BID OPPORTUNITY NO. 630-2019

NORTH END WATER POLLUTION CONTROL CENTRE
 REHABILITATION OF DIGESTER No. 11, SLUDGE HOLDING TANKS No. 5 AND No. 7

DIGESTER No. 11 GAS COLLECTION SYSTEM P&ID

CITY DRAWING NUMBER 1-1010D-A0106-001

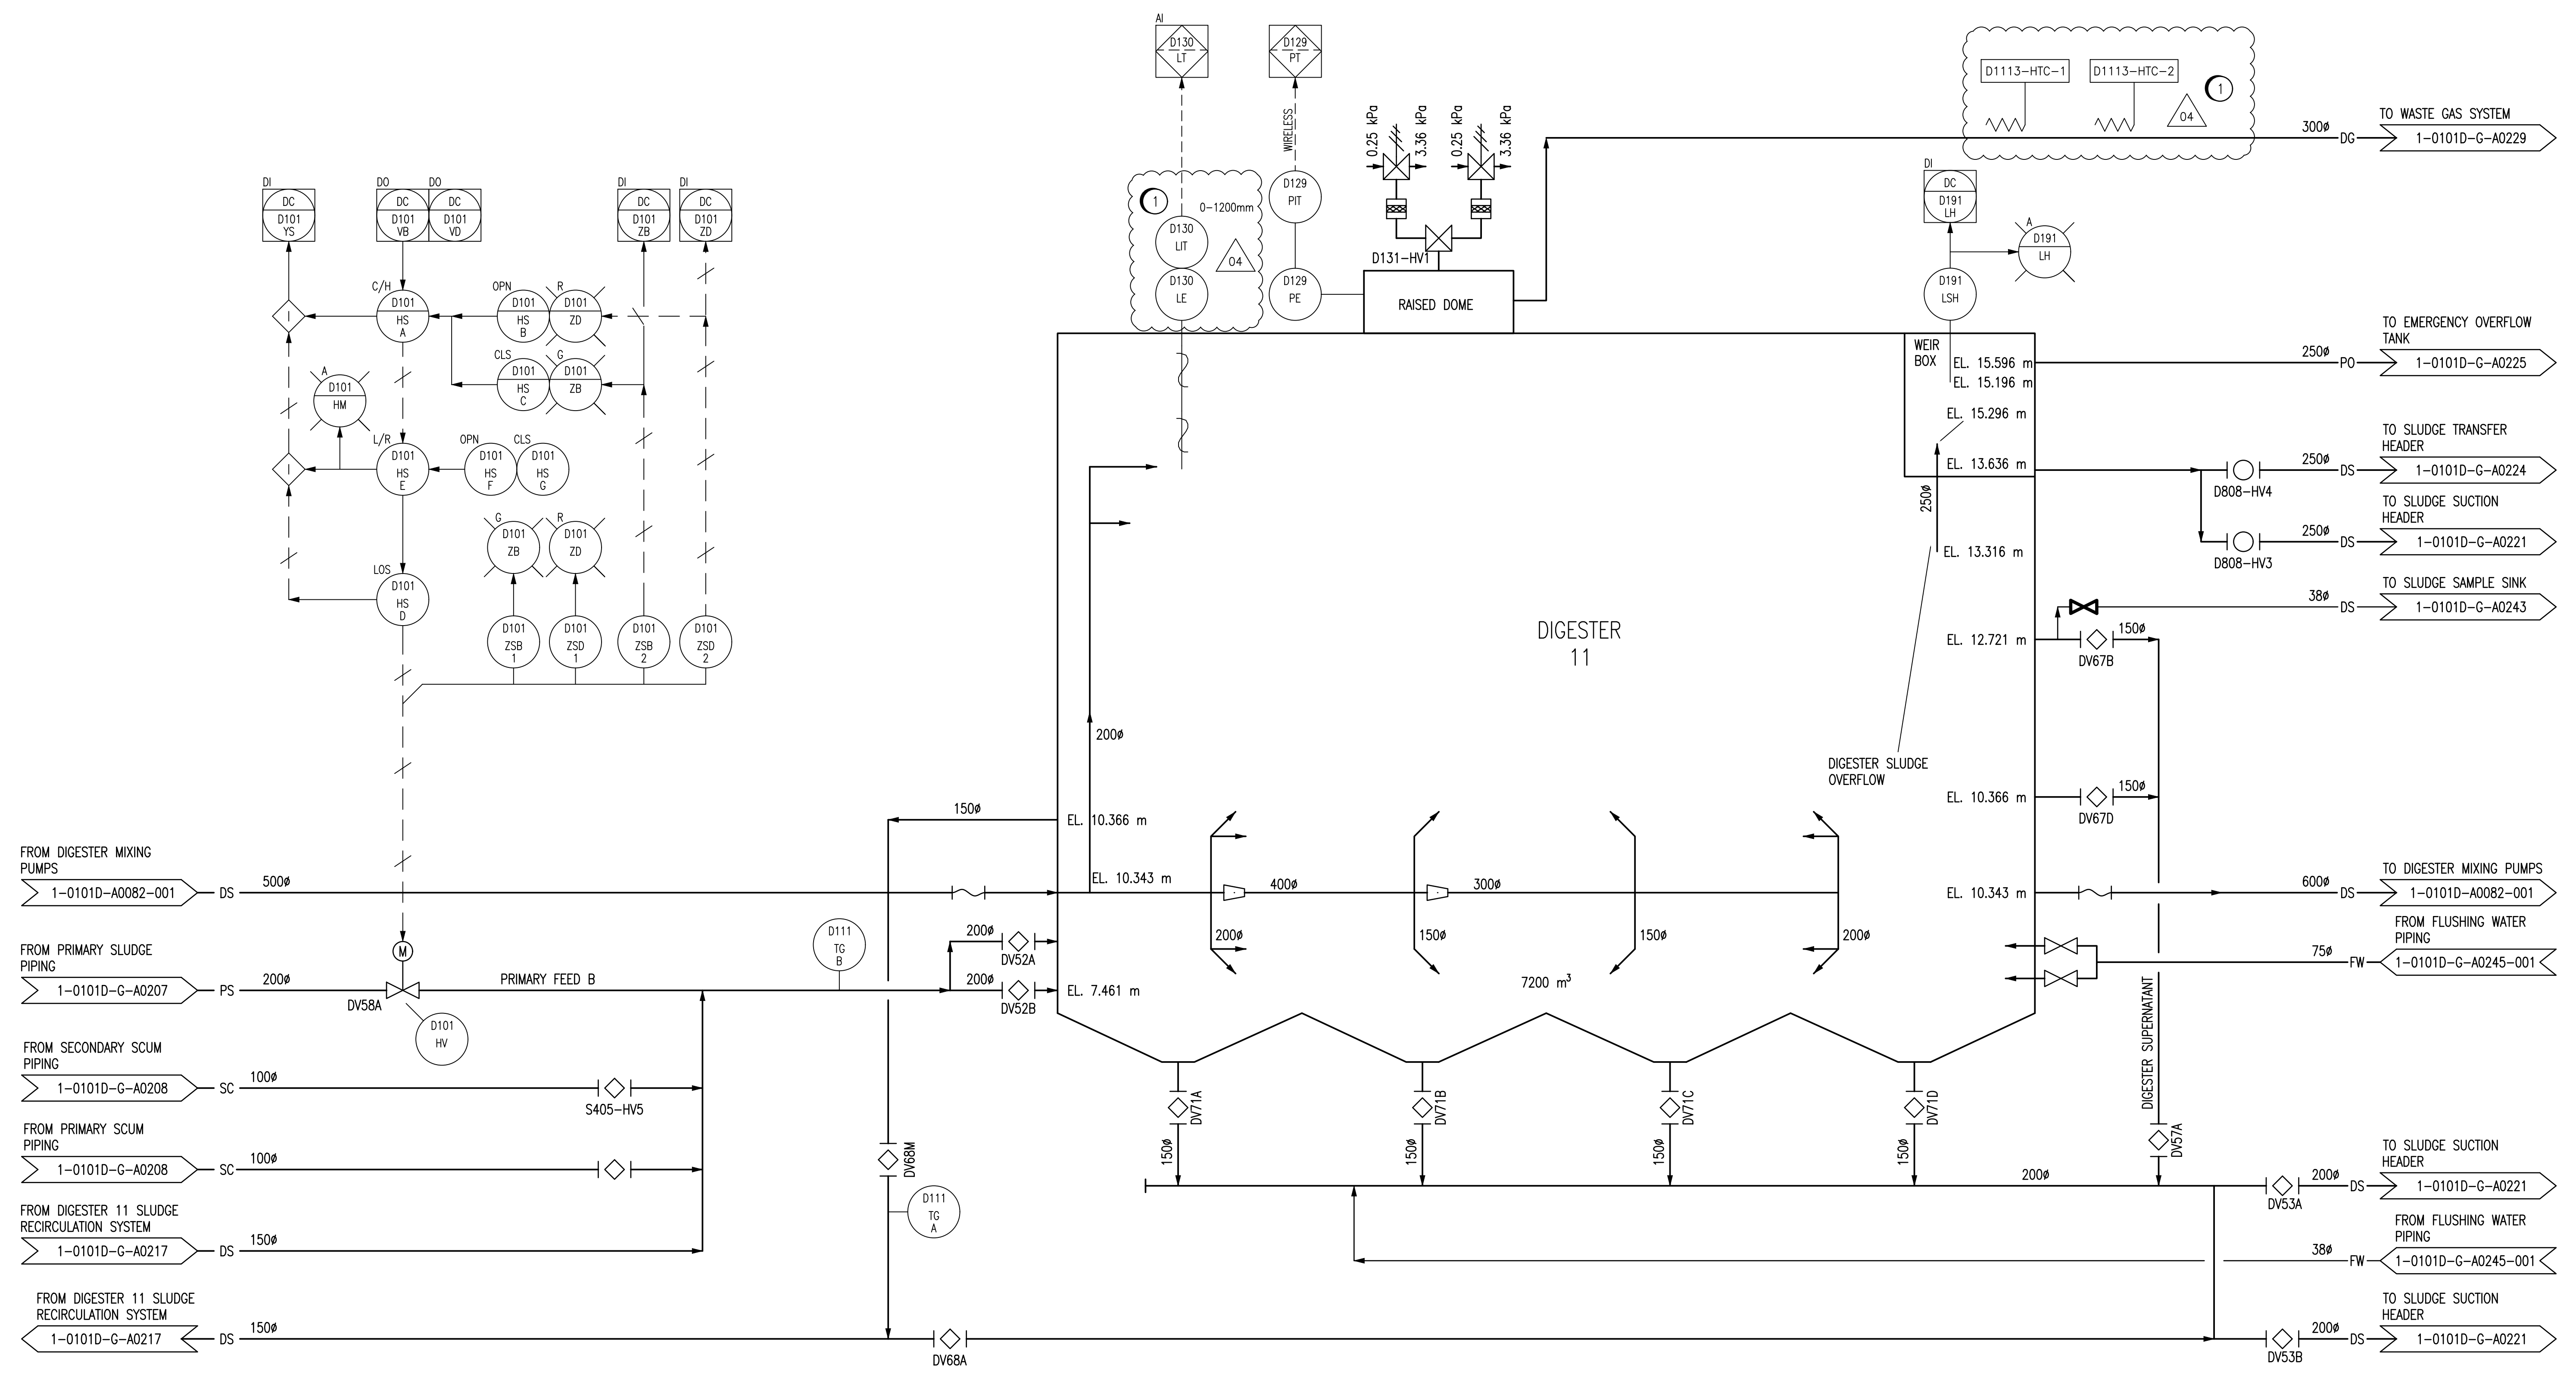
CONSTRUCTION NOTES:
 1 INSTALL NEW ELECTRICAL FITTINGS AND CONNECTIONS FOR THE HAZARDOUS LOCATION.

REVISION 04
 THE ENGINEER'S DESIGN RESPONSIBILITIES ARE LIMITED TO THE CHANGES INDICATED IN THE CLOUDED WORK
